# Product Change Notification

Date Issued :	August 08, 2024	PCN Number :	515605
Reason for Change :	Capacity change or tool replacement		
Description of Change :	This is to inform you of the following changes		
Reason for Short Notice :	Capacity Increase		
Assessment of Change :	No change to parts - Form/Fit/Function		
Planned Implementation Date :	November 30, 2024		
Customer Sample Availability Date:	September 15, 2024		
Last date to request Samples by Customer : September 30, 2024			
Please note if Samples are not requested as per Customer Samples Request date, it may take additional 4-6 weeks to arrange Samples.			
Traceability Code Markings / Date :	Cavity identification

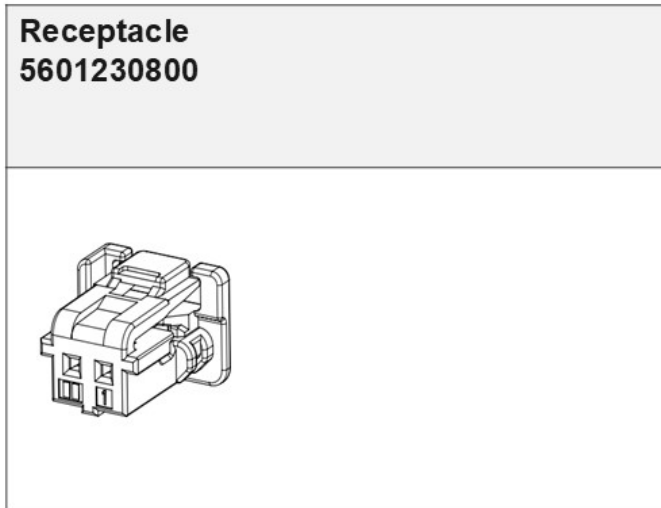
- Affected products as shown below,

- Due to OEM increase in product, we are experiencing extremely high demand beyond our capacity to respond within lead time. Molex is expediting capacity tooling to increase output and qualifying new location of same vendor to ensure the supply chain stability.
- Product Impact
  - “no impact to fit, form or function”
- Part Number Impact
  - Please refer attached impacted part list.
- Qualification Reports and samples available upon request.
